BEAVER VALLEY - UNIT 1

3/4 6-2
PROPOSED WORDING

ATTACHMENT B
SAFETY EVALUATION

Proposed Change Request No. 101 amends the Beaver Valley Power Station, Unit No. 1 Technical Specifications, Appendix A surveillance requirement 4.6.1.2a and associated bases 3/4.6.1.2 concerning the Type A test frequency.

FIGURE No. 1 - CILRT CHRONOLOGICAL ILLUSTRATION

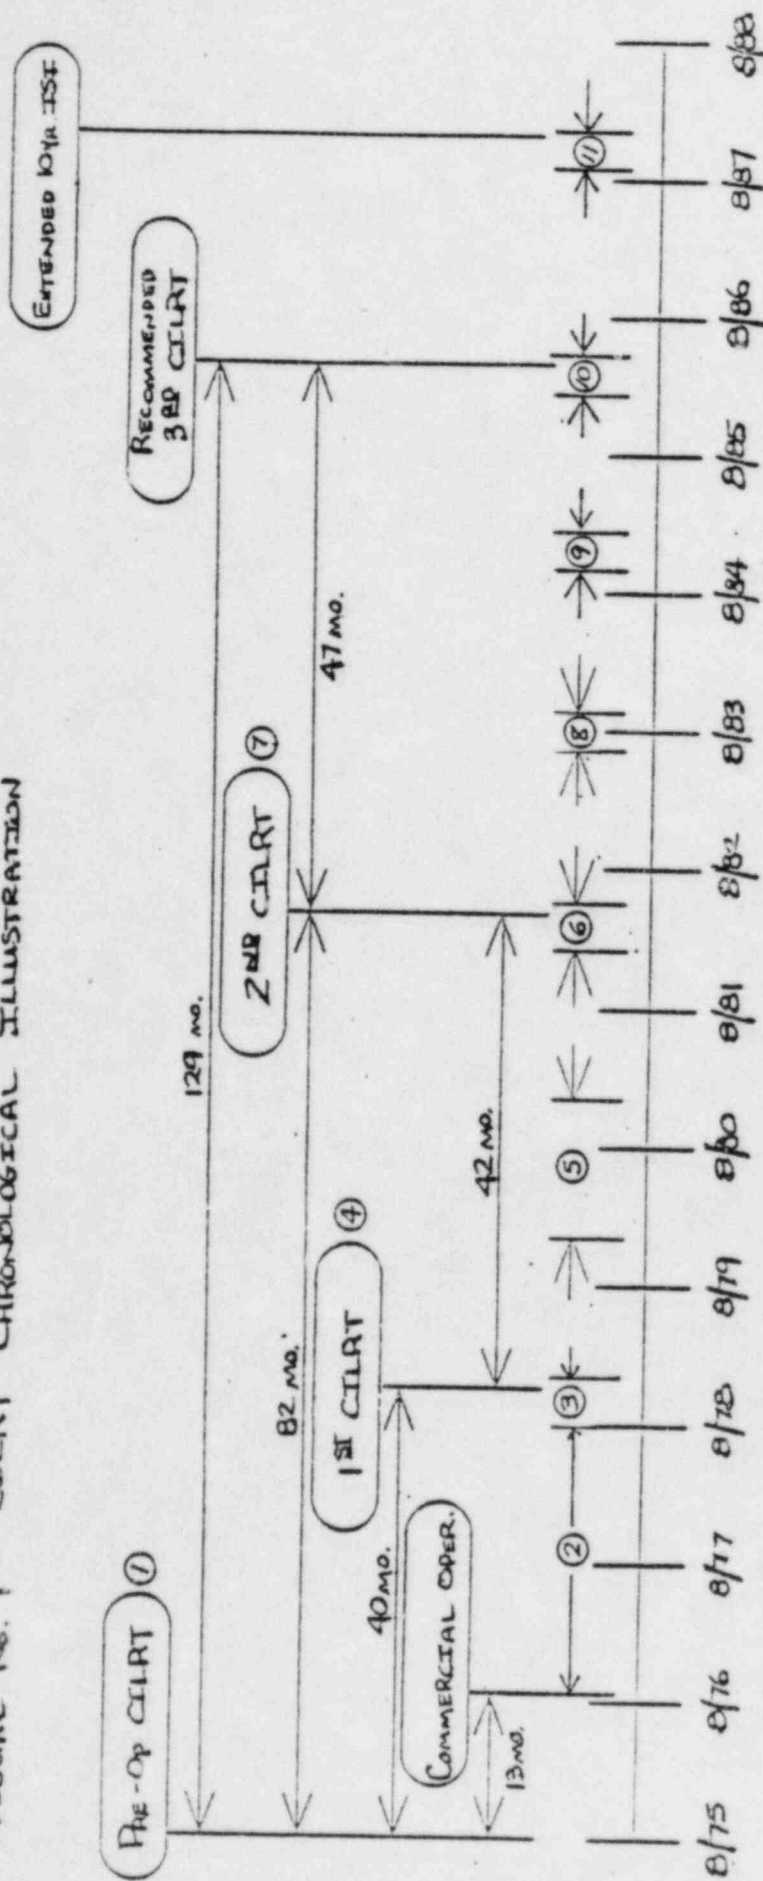
Currently the third Type A Containment Integrated Leak Rate Test (CILRT) is scheduled for the fifth refueling outage (47 months following the second CILRT), see attached Figure 1 (CILRT Chronological Illustration), which provides the past and future outage schedules. The 10-year inservice inspection is scheduled for the sixth refueling outage, therefore, the third CILRT cannot be performed during the shutdown for the 10-year inservice inspection as required by the present Technical Specification requirements.

Surveillance Requirement 4.6.1.2a has been revised to establish a 40 ± 10 -month frequency for the Type A CILRT's. An exemption to 10 CFR 50 Appendix J.III.D.1(a) is also requested, as identified by the note applicable to the above surveillance requirement and specified in the applicable bases. This change and exemption will eliminate the need to perform the third CILRT of each set during the shutdown for the 10-year inservice inspection and will allow more flexibility in the scheduling of CILRT's based on a 40 ± 10 -month frequency.
